**MINOR SITE PLAN REVIEW COMMITTEE
THURSDAY, AUGUST 14, 2025 - 1:00 PM
COUNCIL CHAMBERS, CITY HALL OR
REMOTE VIA VIRTUAL PLATFORM
LEBANONNH.GOV/LIVE**

- A. **Zi Chen, 16 Parkhurst Street (Tax Map 92, Lot 61), zoned LD & R-2:** Applicant requests Minor Site Plan review of a proposed conversion of the existing two (2)-family dwelling to a five (5)-unit multi-family dwelling, together with associated site improvements. **PB2025-34-MSP - Continued from July 10, 2025** [Information previously distributed](#) & additional materials attached
- B. **Michael Davidson, 3 Campbell Street (Tax Map 92, Lot 65), zoned LD:** The property is improved with a main building utilized as a mixed-use office and multi-family dwelling, and a carriage house utilized as a multi-family dwelling. The Applicant requests Minor Site Plan Review to add additional dwelling units to the property for a total of twelve (12) dwelling units, and to convert the use of the main house to a multi-family dwelling only. **PB2025-35-MSP - Continued from July 10, 2025**

TO: Lebanon Minor Site Plan Review Committee
FROM: Planning and Development Department Staff
RE: 16 Parkhurst Street, Tax Map 92 Lot 61
DATE: August 5, 2025

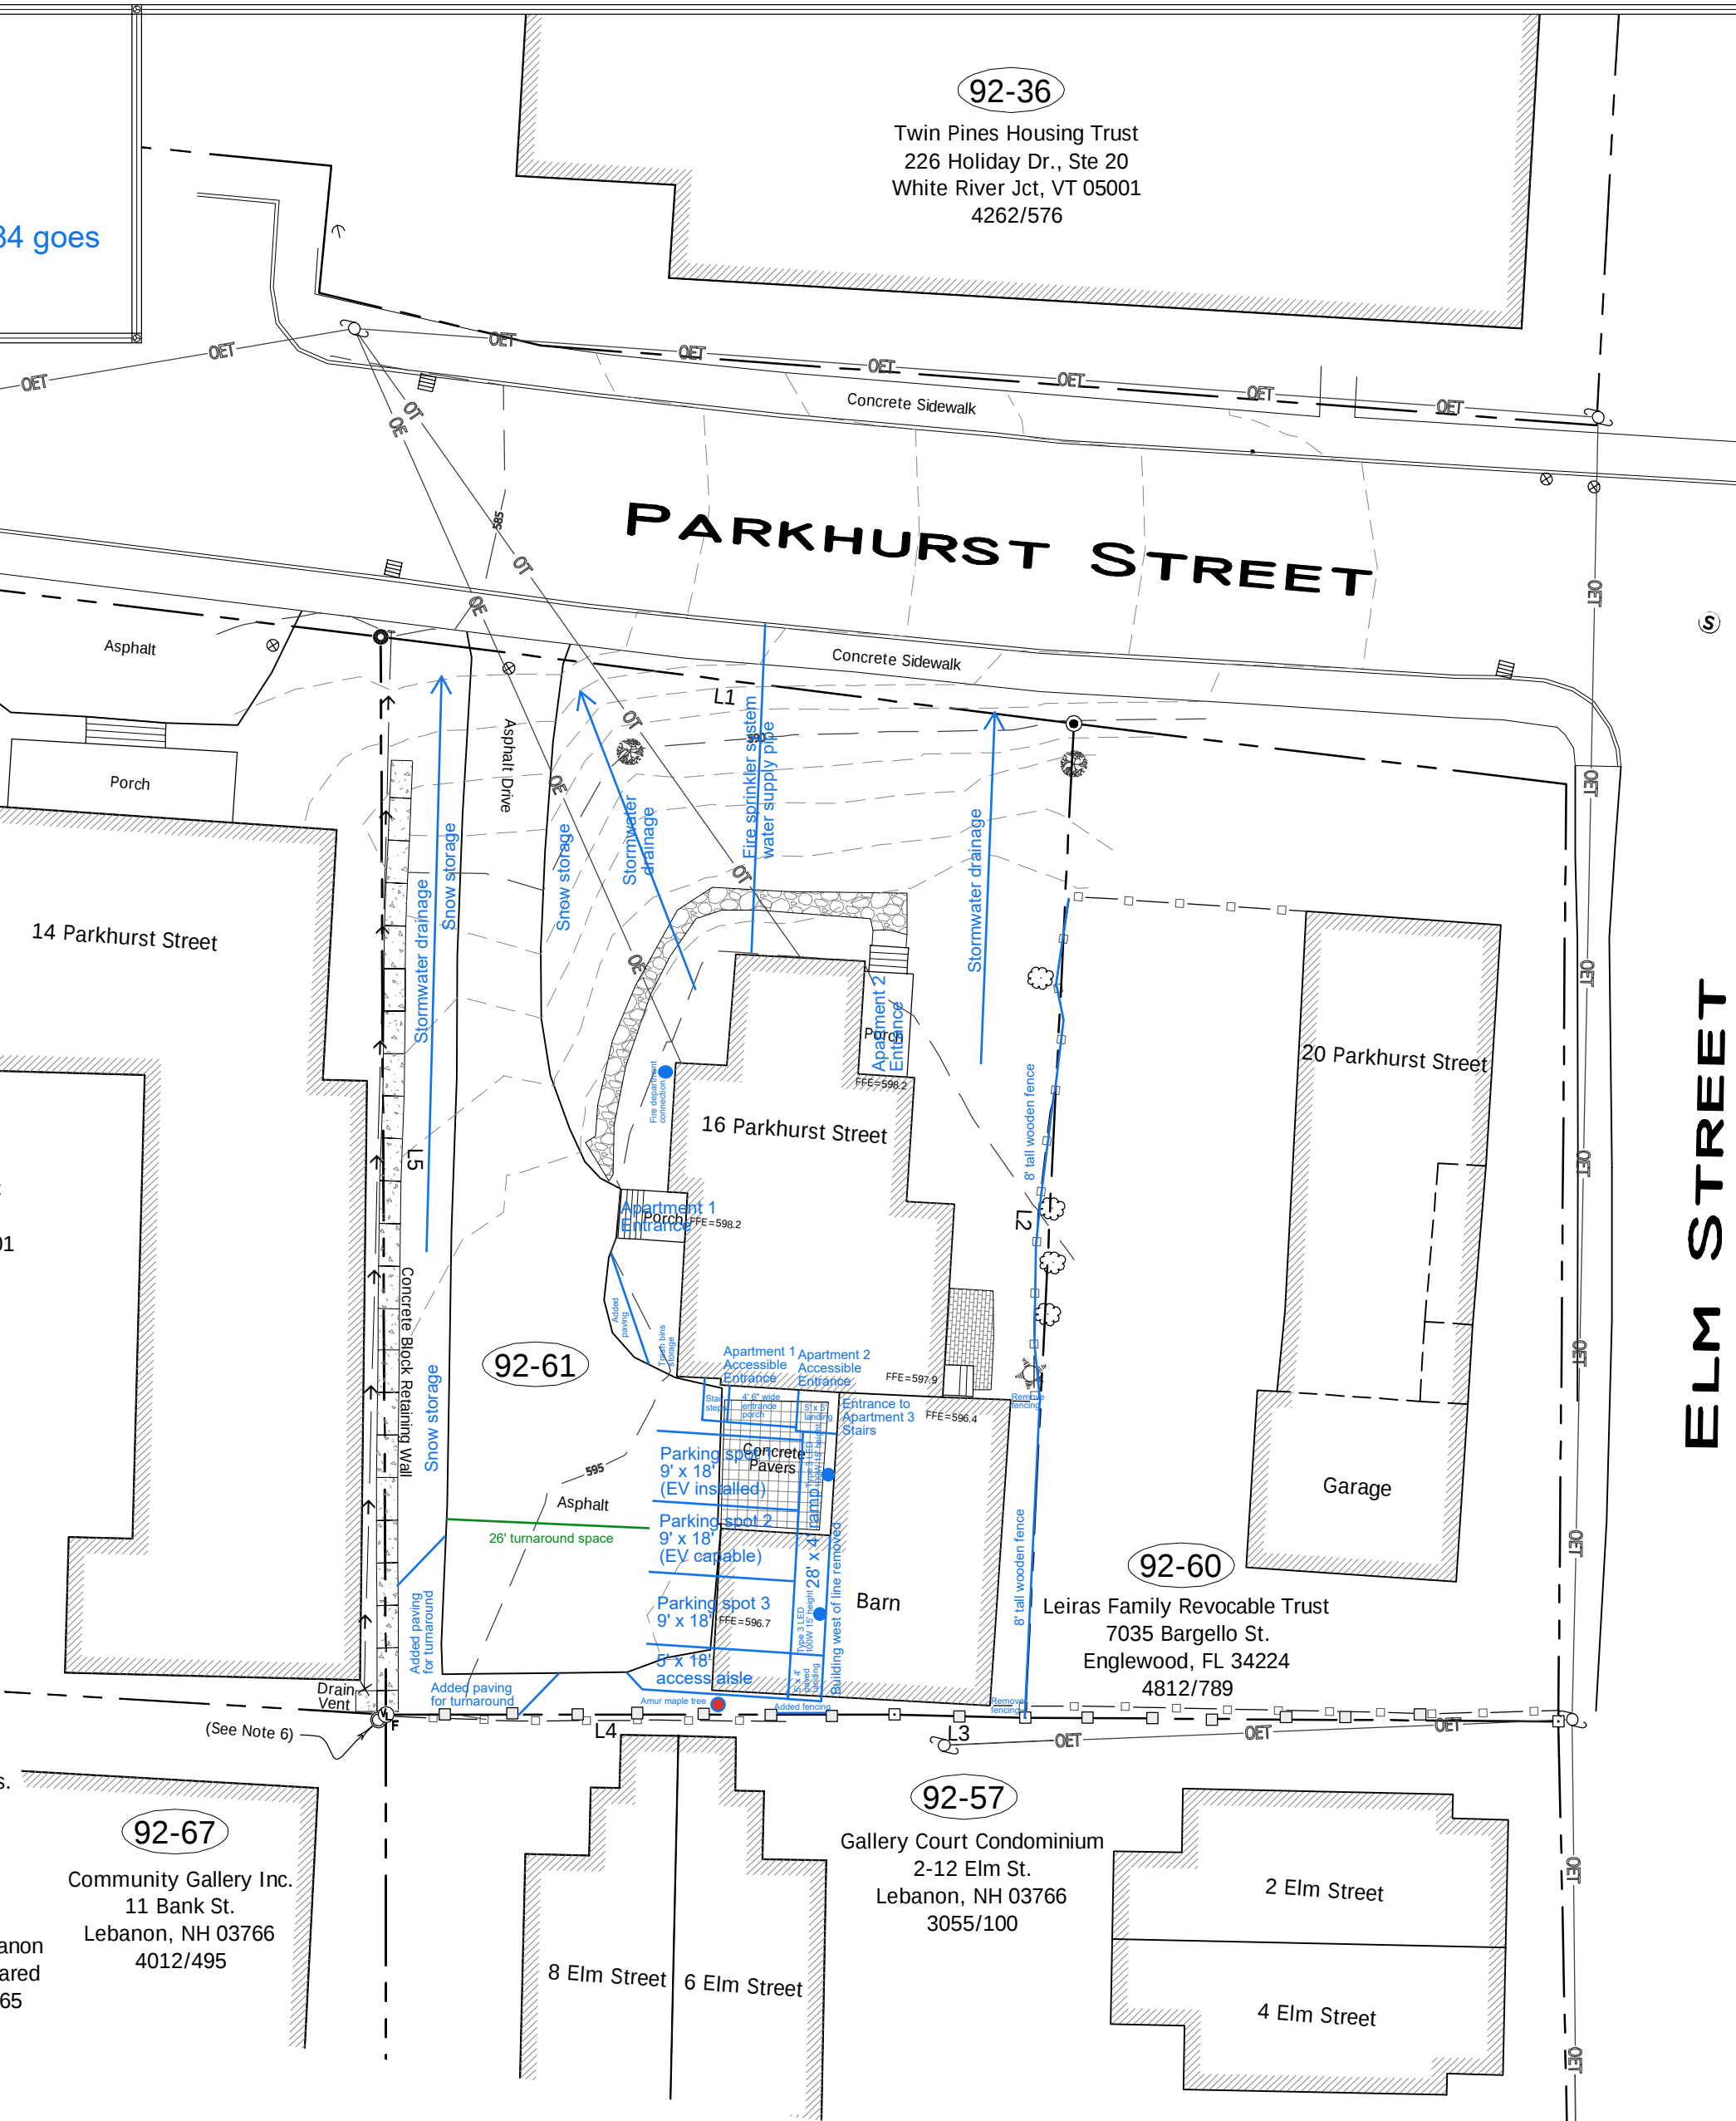
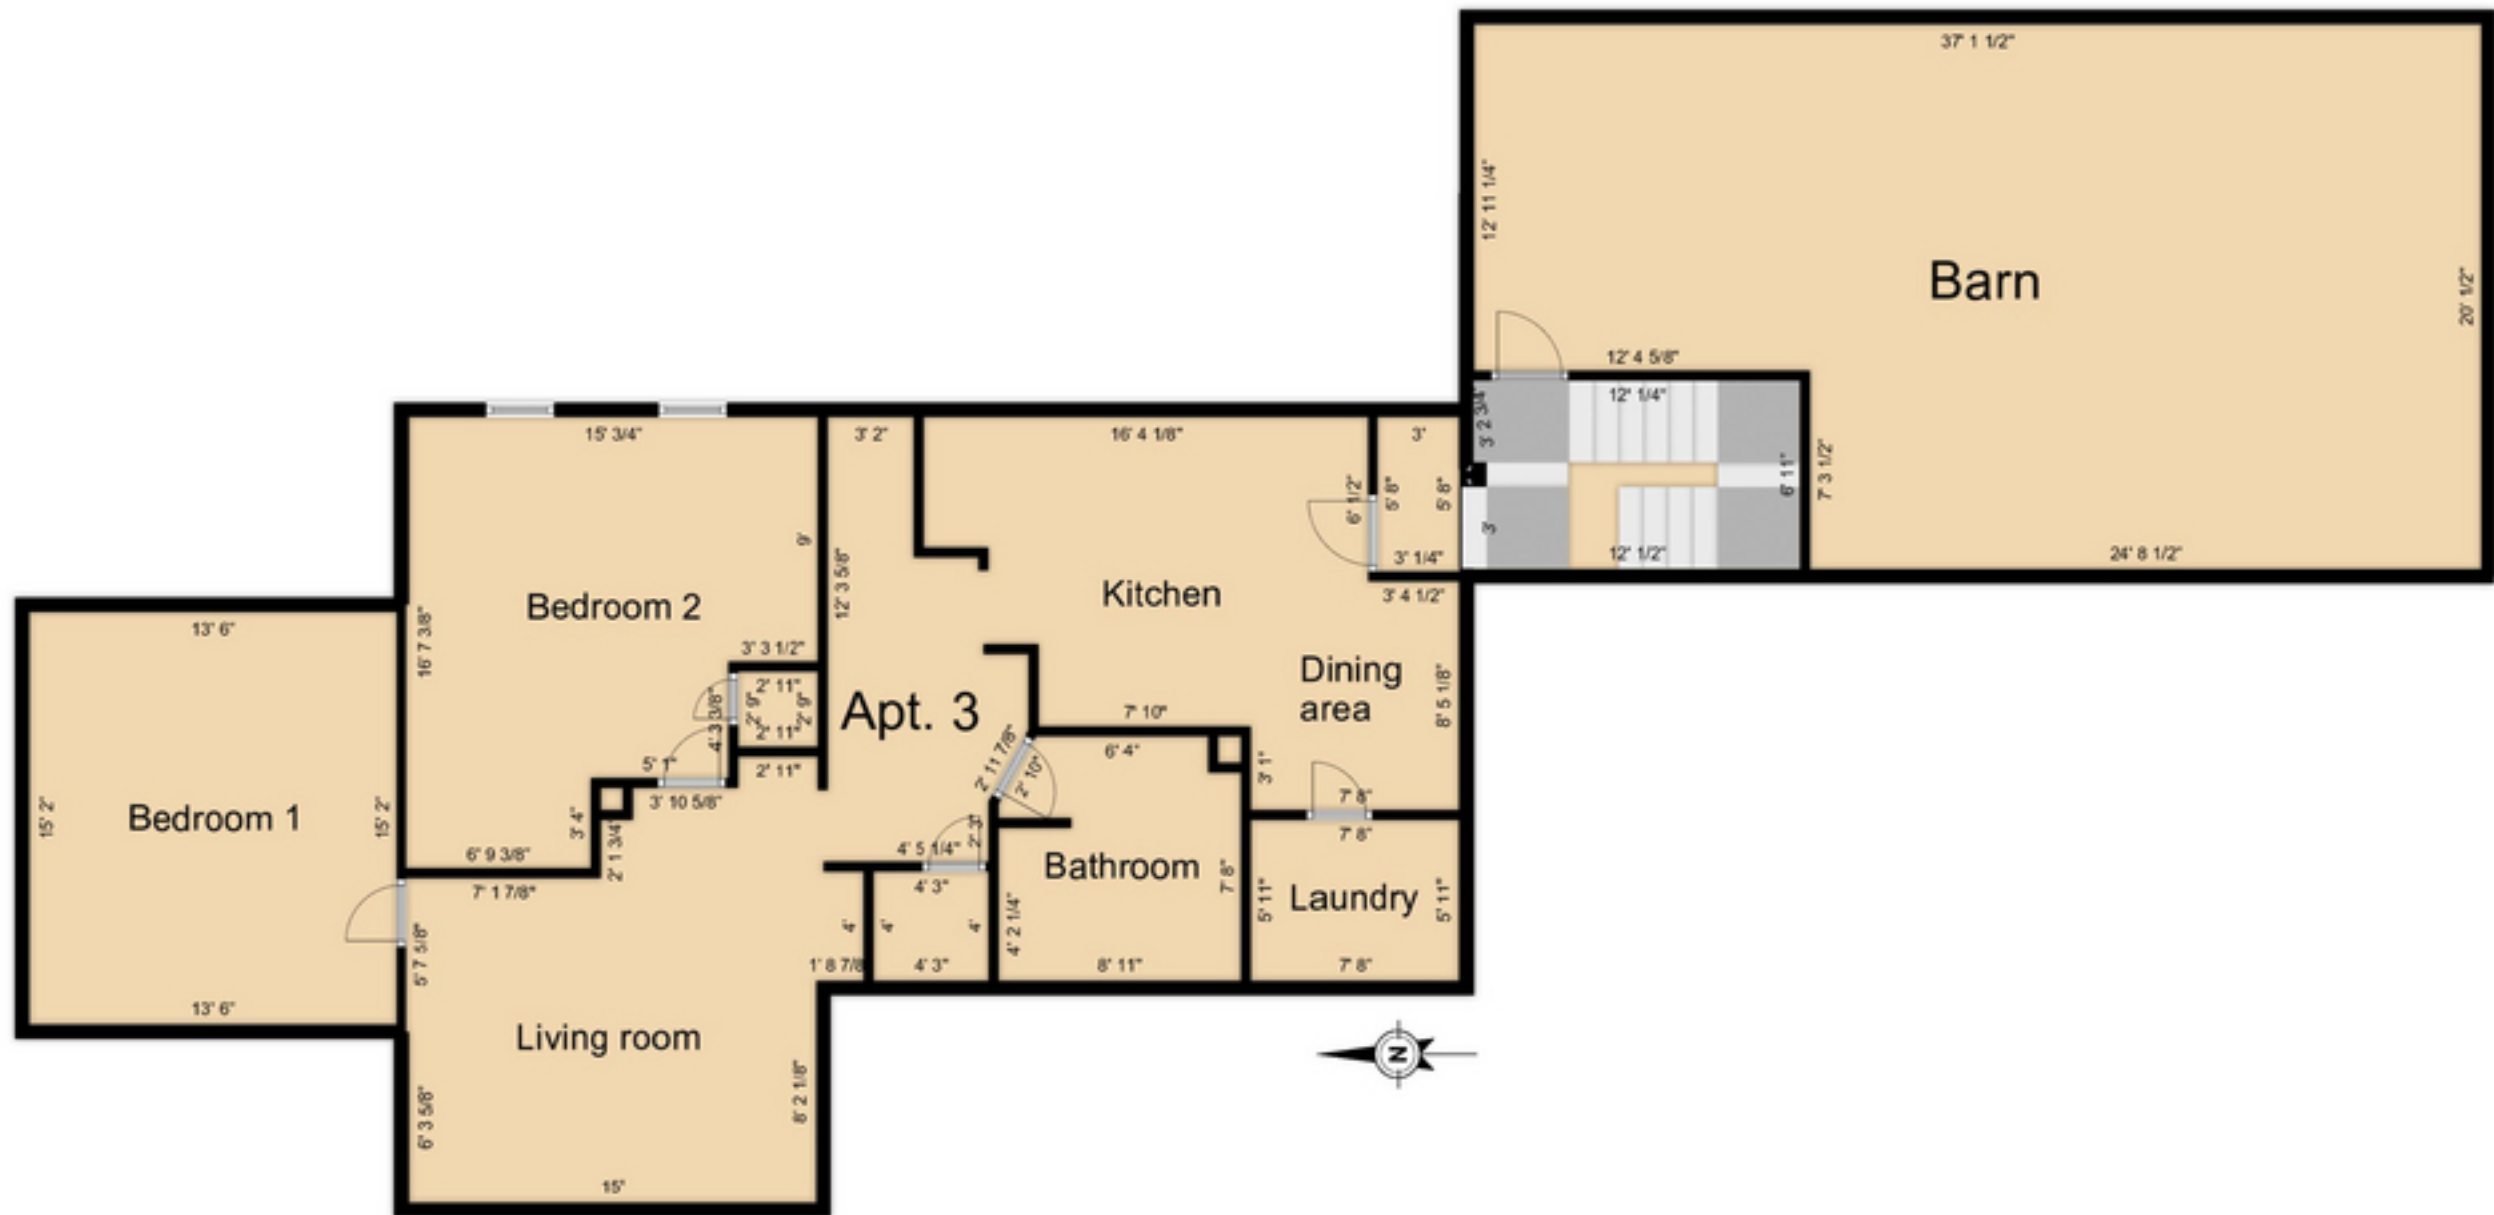
The site plan I am submitting takes into account the feedback on parking from the previous meeting. There is no longer the proposed parking spot northwest of the building that had an awkward turning angle and extended somewhat in front of the front building line. There is now 18 inches of clearance between the side of the northmost parking spot and the entrance porch. Most importantly, all three parking spots now have at least 25 feet of space to the west for the vehicle to turn around before exiting.

To make room for the parking spots and turnaround, the site plan proposes to remove a portion of the barn. The land below this portion of the barn (and the elevated entrance area) will be regraded to ensure that it is no more than 28 inches below the elevation of the floor level of the first floor of the building and to ensure that the sloping of the accessible parking space and the access aisle are not greater than 1:48. Once this is done (and EV capability is installed), the land for the parking space, the access aisle, and the bottom landing of the ramp will be paved with asphalt. Paving will also be added in the southwest corner of the lot to create additional turnaround space for vehicles.

The site plan includes an access aisle south of Parking Spot 3. This access aisle will be connected to a 28 foot long ramp to provide an accessible route to an entrance for both downstairs apartments. (There is an elevation difference of 29 inches between the first floor of the building and the paved surface below, and the sloping of a ramp cannot exceed 1:12. However, Parking Spots 1 and 2 can slope up to 1:15, which will allow the elevation difference to be reduced by at least 1 inch.) The ramp is given 48" of width in the site plan to allow for an outer guard and handrails on both sides while still providing 36" of clear width. The entrance porch is given 60" of depth at the top ramp landing and 54" otherwise to allow an outer guard while still providing 48" of clear width in front of the Apartment 1 Accessible Entrance. The entrance porch also provides access to the stairs that lead up to Apartment 3 and the upstairs of the barn.

For lighting, I plan on installing two Alcon Dark Sky-compliant Type 3 100W LED lights (see attached specifications sheet). They will be mounted on the wall of the barn in the locations indicated in the site plan. Each light would have a photocell so that it only operates dusk to dawn and a dimmer switch to allow the lighting to be dimmed if it is too bright.

To meet building and fire code requirements for a fire sprinkler system, I will run a second water service pipe from the city supply to the building so that the fire sprinkler system is supplied independently of the domestic water supply. If in the process I also come across the existing sewer pipe and it is made from cast iron, I will most likely replace it with a PVC pipe. I understand that an excavation permit is required for this work. The path for the additional water service pipe and the location of the fire department connection for the fire sprinkler system are indicated in the site plan.
